Hearing Date: August 14, 2014
Case No.: **2013.0154E**
Project Name: **MOSCONE CENTER EXPANSION PROJECT**
Project Address: 747 Howard Street
Zoning: Downtown Commercial Support C-3-S
340-I Height and Bulk District
Block/Lot: 3723/115 and 3734/91
Project Sponsor: John Noguchi
Director of Convention Facilities Department
City and County of San Francisco
747 Howard Street, 5th Floor
San Francisco, CA 94103
Staff Contact: Elizabeth Purl – (415) 575-9028
Elizabeth.Purl@sfgov.org

DATE: July 30, 2014
TO: Members of the Planning Commission and Interested Parties
FROM: Sarah Jones, Environmental Review Officer
RE: **Attached Responses to Comments on Draft Environmental Impact Report Case No. 2013.0154E for the Moscone Center Expansion Project**

Planning Department Case No. 2013.0154E
State Clearinghouse No. 2014012050

Figure II-10b (REVISED)
Proposed Landscaping Plan

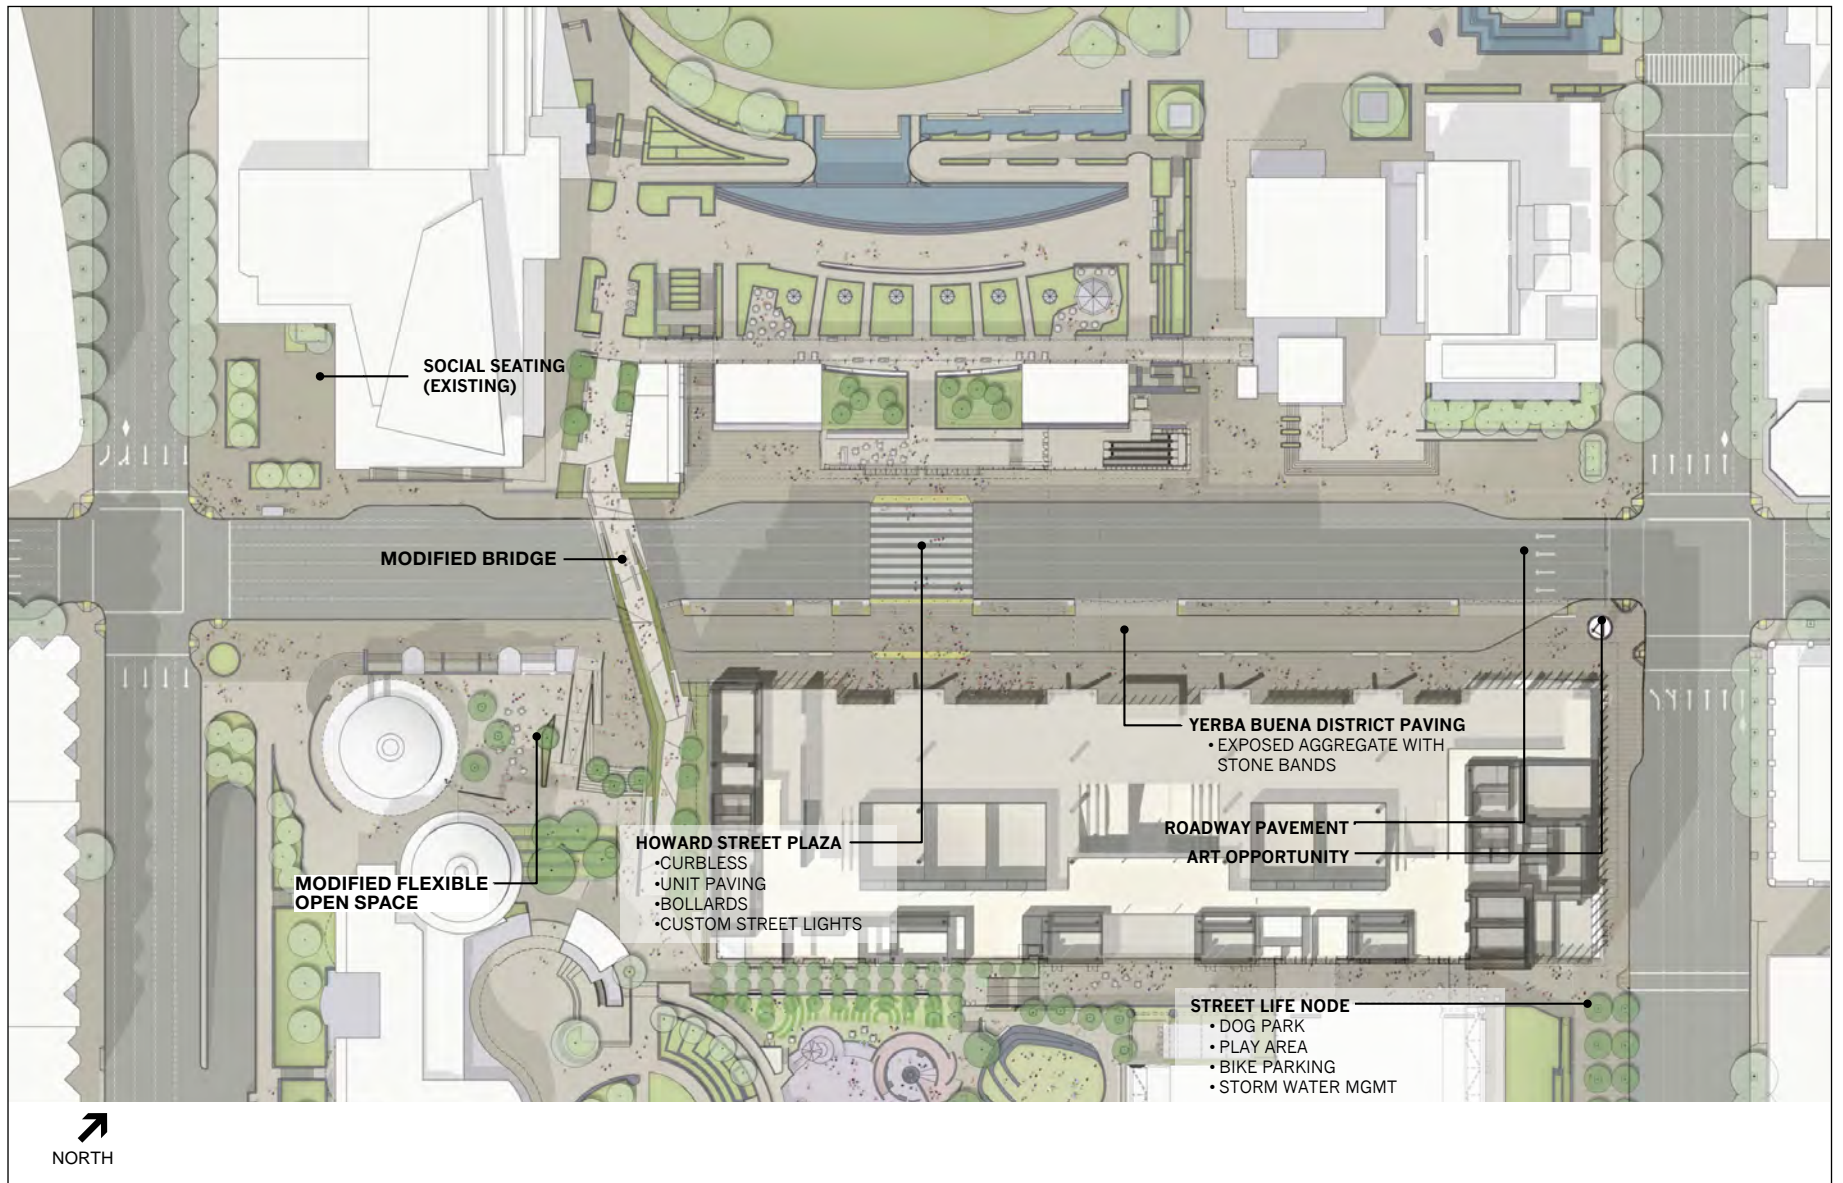
- Figure II-10b shows revisions to the proposed landscaping plan, including in the area of the western pedestrian bridge landing and the flexible space east of the carousel, as well as the modified western pedestrian bridge, as well as the updated plans for the flexible open space in the Children's Garden.

Moscone Center Expansion Project 2013.0154E
Figure II-11 (REVISED)
 Proposed Howard Street Conditions

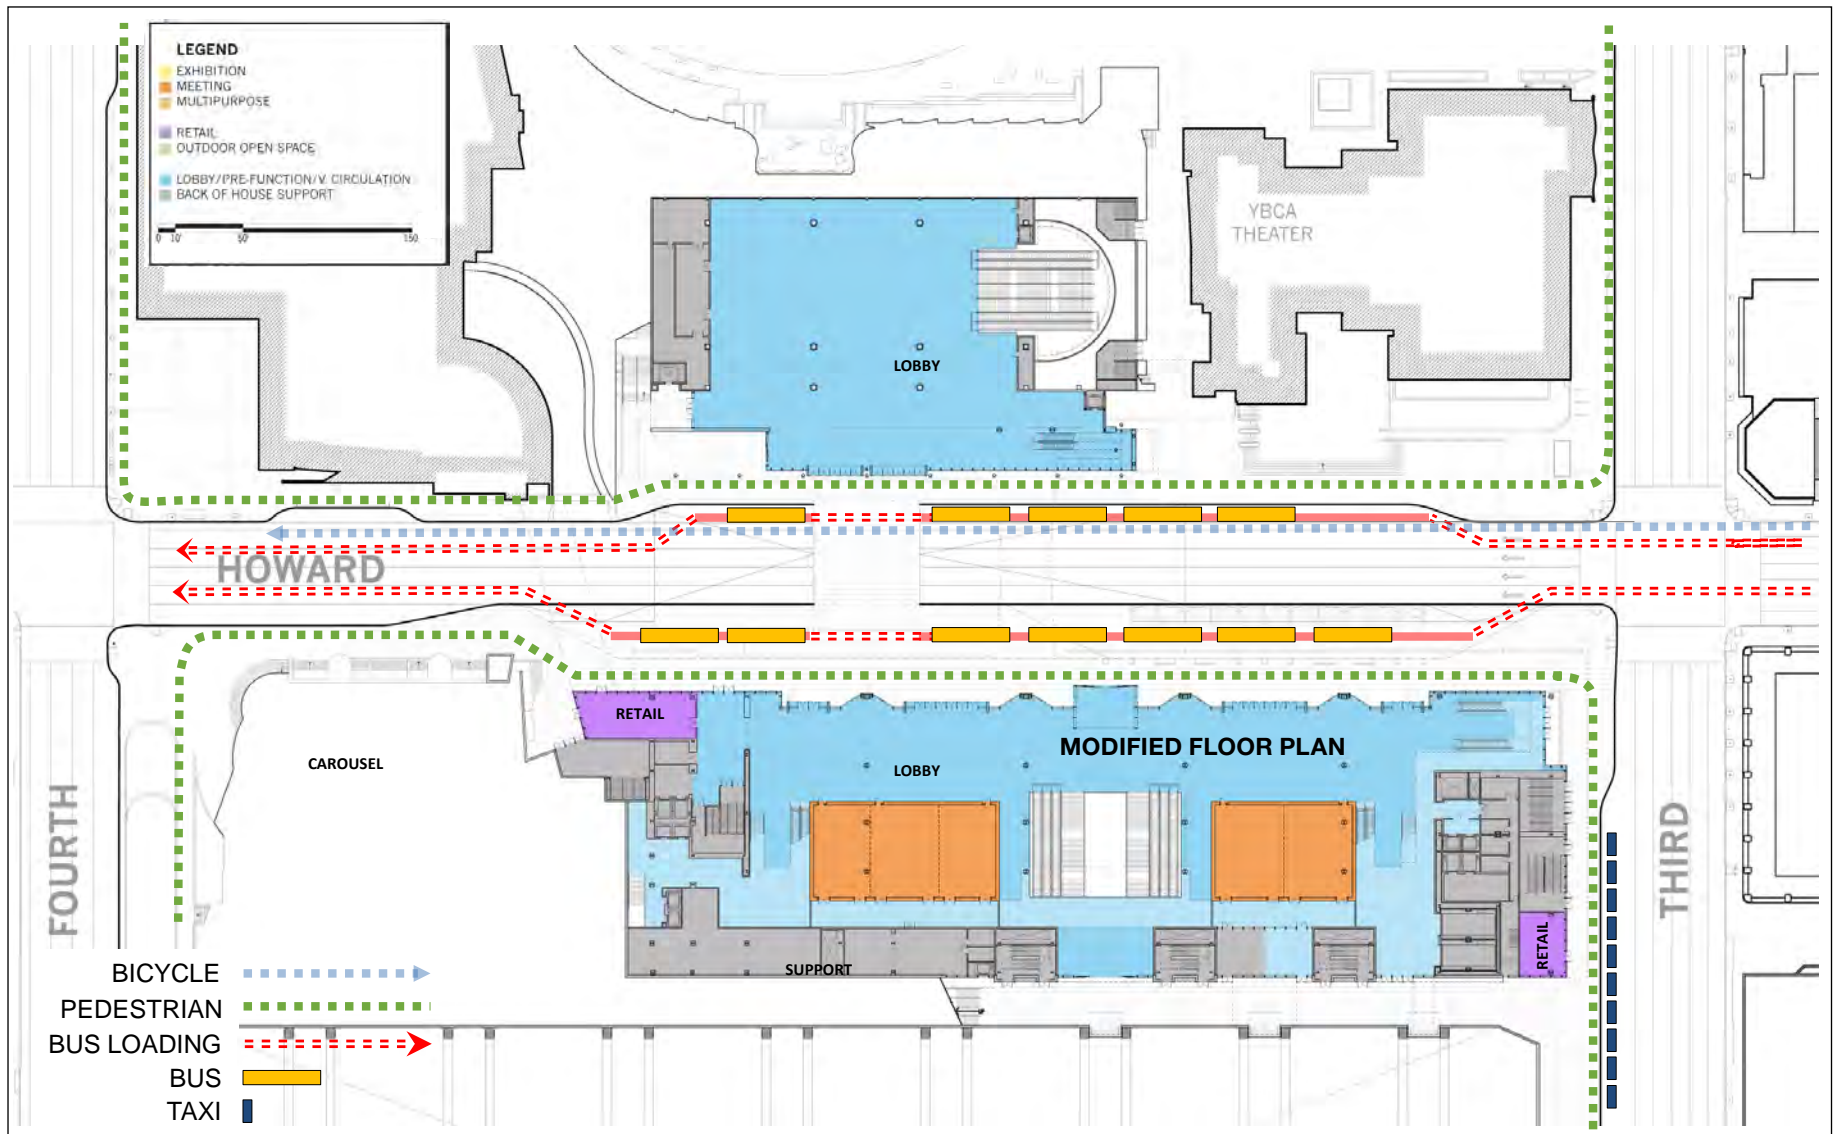
"Pages II-22, fig II-11 shows some of the graphic symbols which I assume are used mostly thru out this Document. For example, the light blue dashed line represents a bike route. Be that the case, does this mean that there will still be a bike route (Page II-7, figure II-2) shows an existing Bike Route, I did not realize bikes were allowed in the garden area. This is shown on page II-10, figure II-3 shows a proposed (existing) Bike Route, I would have a concern for the safety of the pedestrians in the Garden." (Dennis Hong, email, June 16, 2014)

How will the proposed taxi stand on page II-22, figure II-11 and the Loading Ramp Entry as shown on page II-25, figure II-12 work? Is there enough room for all this?" (Dennis Hong, email, June 16, 2014)"

Figure II-11 on page II-22 presents the proposed Howard Street Conditions. As shown in the lower-left corner, blue is used to indicate bicycle travel on this figure. Please also see the revised Figure II-11 in Section VIII.E of this document. This figure was revised to show modifications to the Moscone South/Esplanade first floor building design and program, but the configuration of Howard Street is identical to that in the original Figure II-11 and that analyzed in the Draft EIR. **Figure II-12** on page II-25 shows the proposed relocation of the Third Street truck ramp entry. As stated above and shown in Figure II-2, the existing Moscone Convention Center includes a truck ramp entry at Third Street. The proposed project would relocate that entry 186 feet southward, closer to intersection of Third and Folsom streets.
